Title			
ACROBAT HANDSET PCB			
Size	Standard	Rev	5
B	SC00136-001		
Date	6/14/96	Drawn by	CWC
Filename	SC001365.001	Sheet	1 of 2

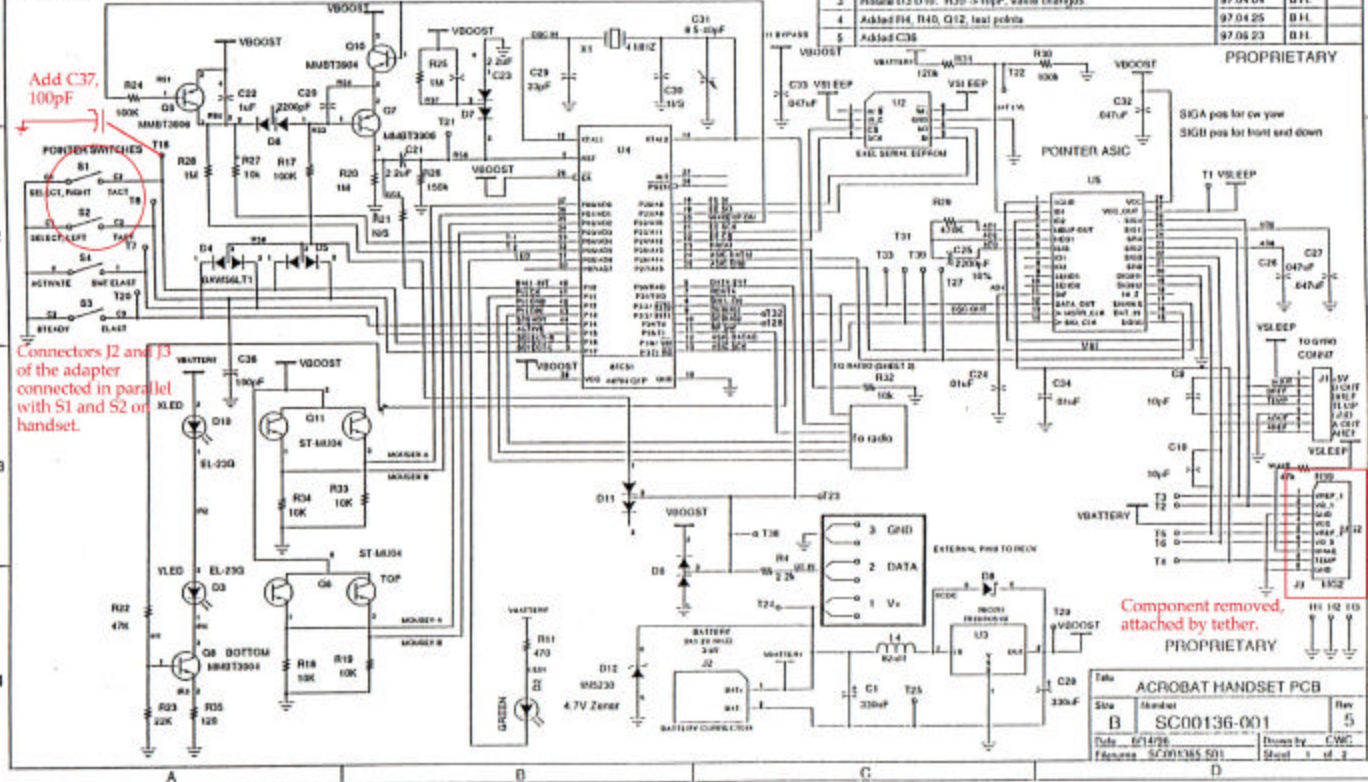
Add C37, 100pF

FOR 30K SWITCHES

Connectors J2 and J3 of the adapter connected in parallel with S1 and S2 of handset.

Component removed, attached by tether.
